Certificate of Appropriateness

41 N Roby Rd

January 11, 2021

PORCH- SIDE ELEVATION

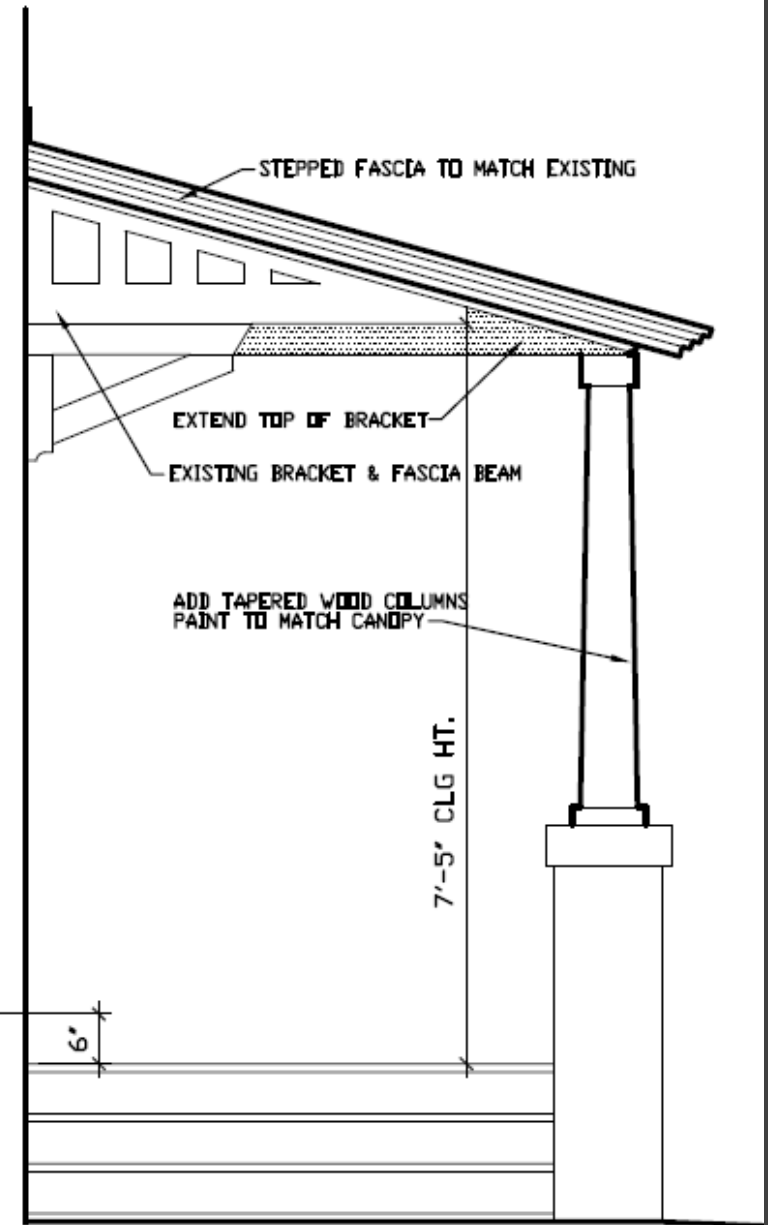
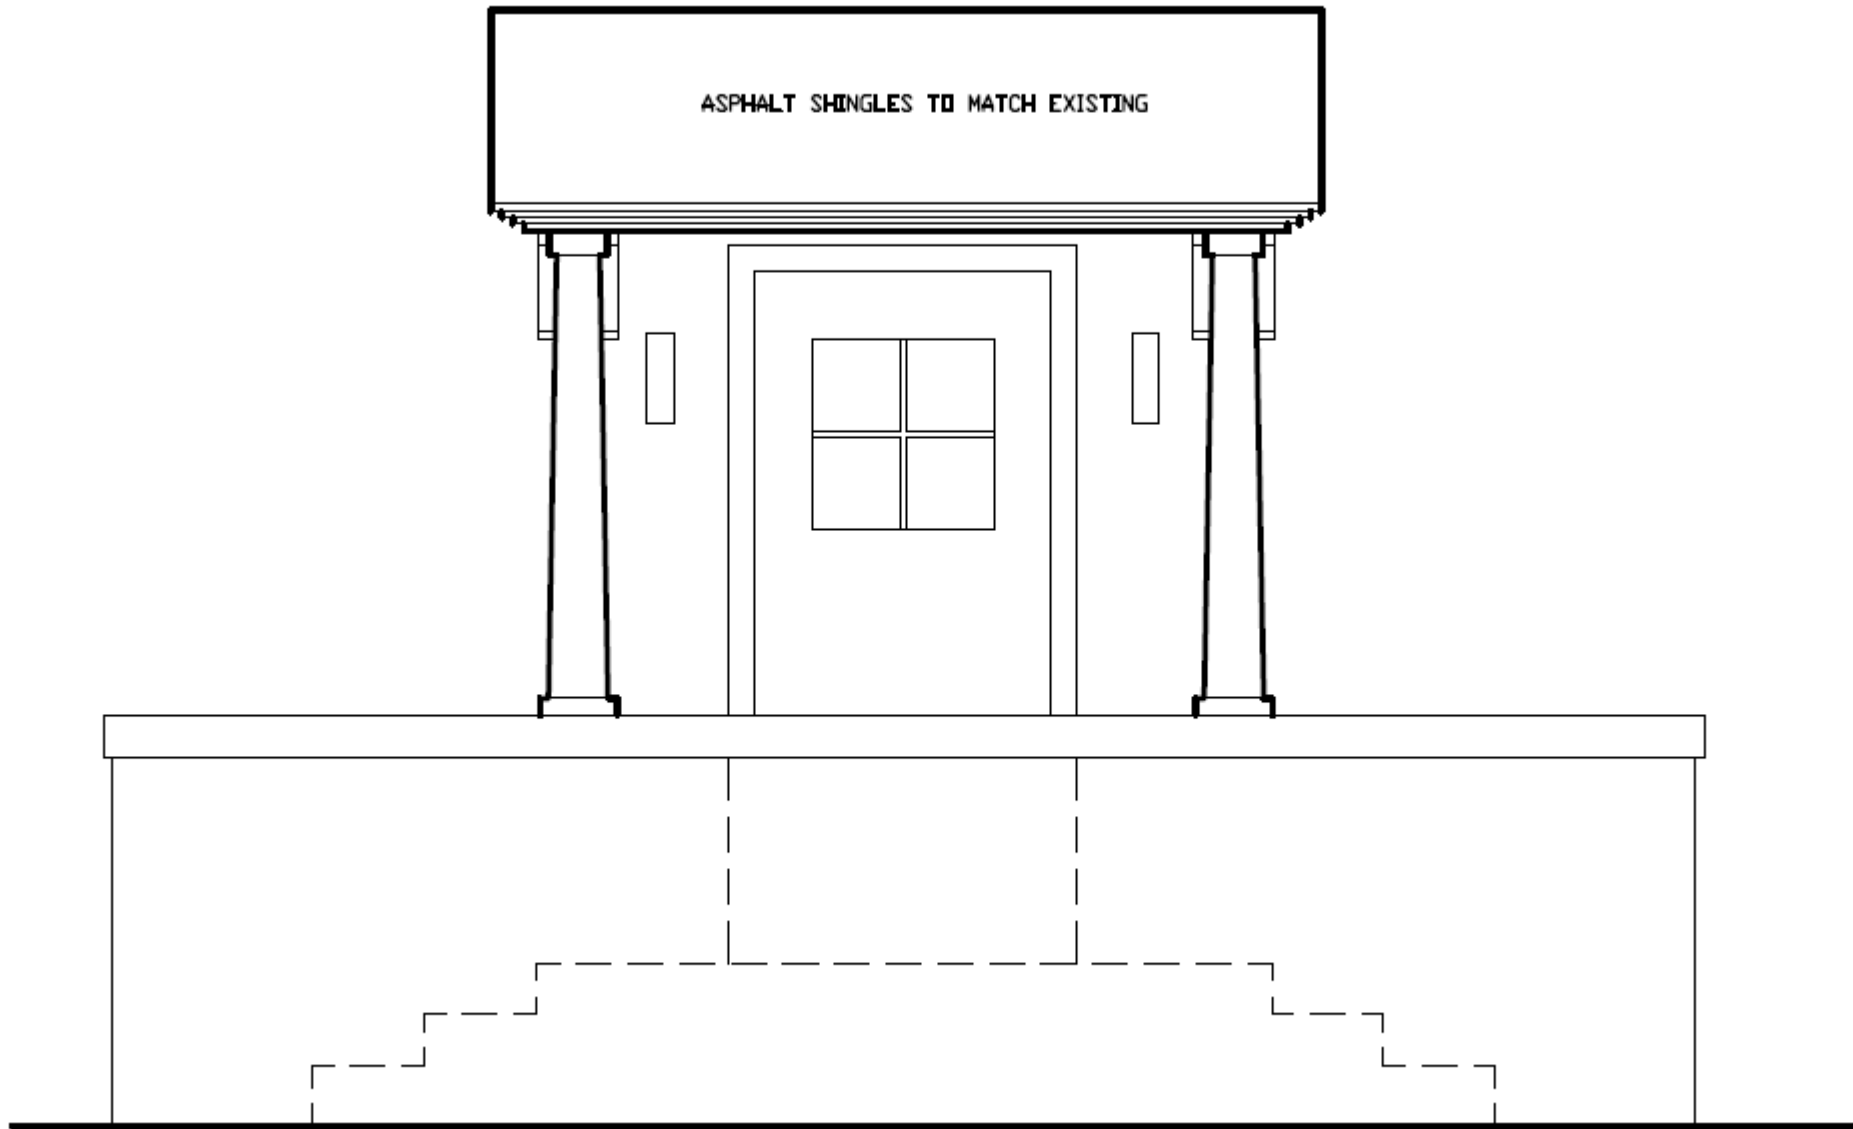
Staff believes that the standards for granting a Certificate of Appropriateness could be met. The Landmarks Commission should evaluate if the proposed alteration to the entryway meets the standards or if the cantilever should be maintained by introducing additional support to the interior.
